UNITED STATES
NUCLEAR REGULATORY COMMISSION
WASHINGTON, D.C. 20555-0001

PROJECT: AP600

SUBJECT: SUMMARY OF MEETING TO DISCUSS AP600 CONTAINMENT WATER pH CONTROL
FUNCTIONAL ANALYSIS AND DESIGN DETAILS

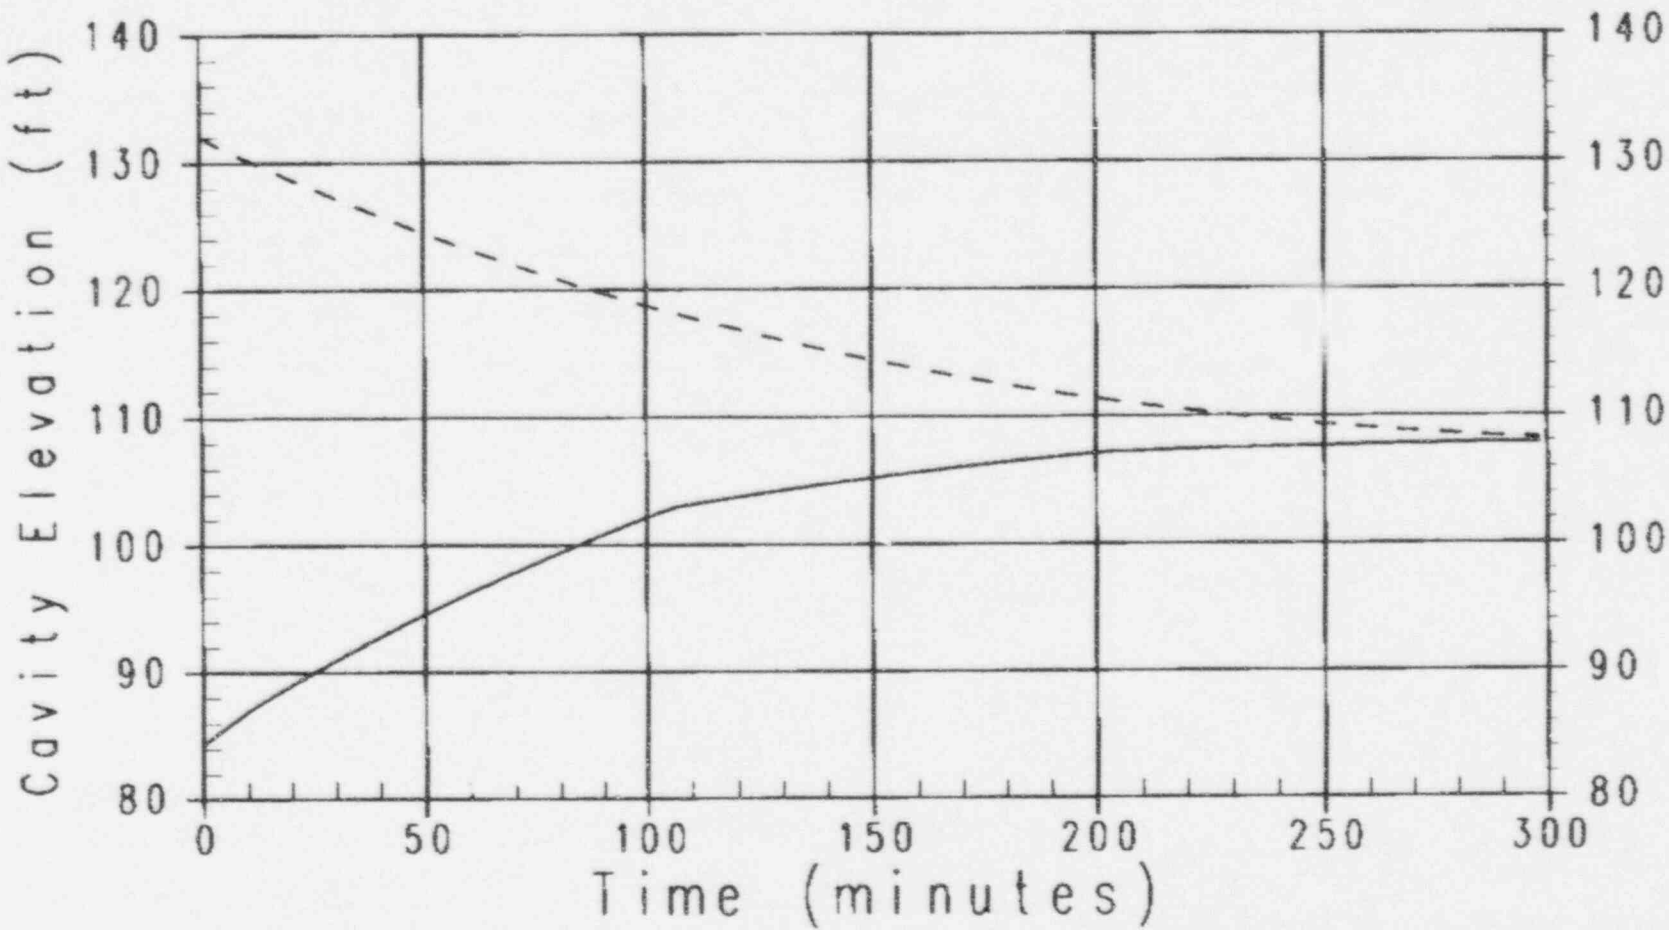
Question 470.30

pH Control System

Provide the configuration of water volumes and water flow paths in the containment for dissolving and mixing the trisodium phosphate following an DBA.

The sources of water and boron that can be involved in post accident flooding of the containment include the following:

The distribution of this water in the containment is described in section 4 of WCAP-1470, WGOthic Application to AP600. Note that the final post accident containment water flood level is about the 108' 2" elevation. Since the IRWST bottom is at the 103' elevation, some of the IRWST will not drain. The IRWST has a internal surface area of 2760 ft²; this results in about 14260 ft³ of water remaining in the IRWST.

In the event of a severe accident, the primary mixing mechanism is natural circulation driven by the hot reactor vessel containing the damaged fuel. Water and steam will flow up along the outside of the hot reactor vessel and into the loop compartments. The water carried into the loop compartments will flow through the corridor between the loop compartments past where the TSP baskets are located and down a vertical access tunnel to the reactor vessel compartment. This flow path promotes mixing of the TSP with the water inside the containment.
